CLIO R3T

REFERENCE	BULLETIN TECHNIQUE N°7 / TECHNICAL NEWS N°7
DATE	27 / 10 / 2014
SUBJECT	Modif Faisceau barillet / Barrel sensor loom modification
PART

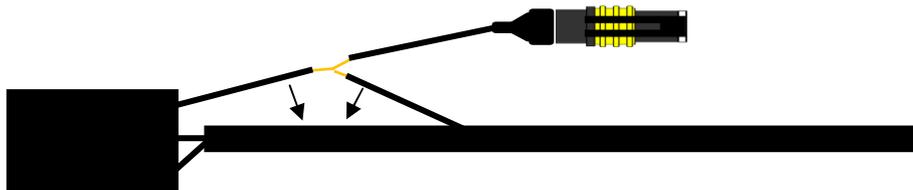
Enlever la gaine thermo sur 6 à 8cm (à partir de l'arrière du connecteur) en faisant une fente afin de ne sortir que le fil lié à la pin3

Couper le fil connecté à la pin3 au milieu et dénuder les 2 parties.

Faire une épissure entre les 2 parties dénudées précédemment en y soudant le faisceau additionnel. Protéger l'épissure avec de la gaine thermo et replacer le tout dans la gaine d'origine. Pour une meilleure finition, vous pouvez dépinouiller les 2 autres pins afin de replacer de la gaine thermo autour du faisceau (bien repérer les pins auparavant).

**Modification : barrel sensor connector side**

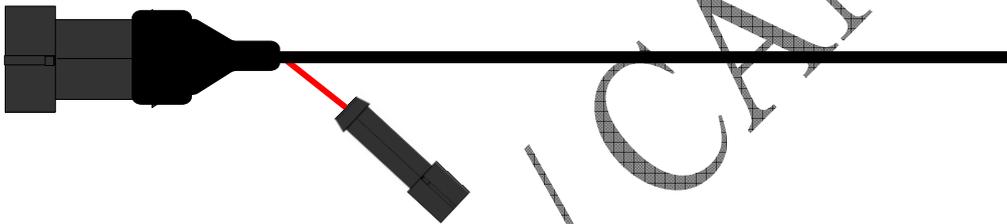
Remove the protection cap

Remove the contact n°1 (red wire) from the connector. You also can remove the other contacts (then replace them in the right place) to use heat shrink and protection cap onto the 3 ways female superseal connector.

Place the removed contact into a 1 way female superseal connector

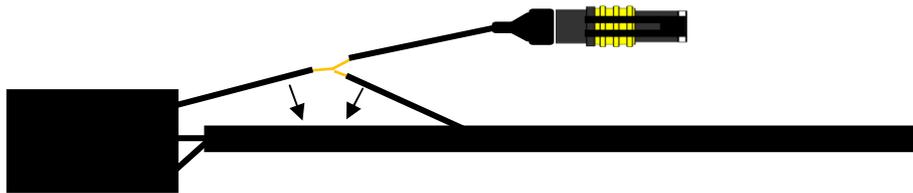
Remove the heat shrink on 6 to 8cm (from the back of the connector) by making a slit to pull out the wire connected to the contact n°3.

Cut the wire to the middle and denude the 2 parts.

Do a splice between the 2 parts and weld the extra loom to them. Protect the splice with some heat shrink and replace it into the original sheath. For a better quality, you can unplug the 2 other contacts to put some heat shrink (be sure to replace the contacts in the correct place).
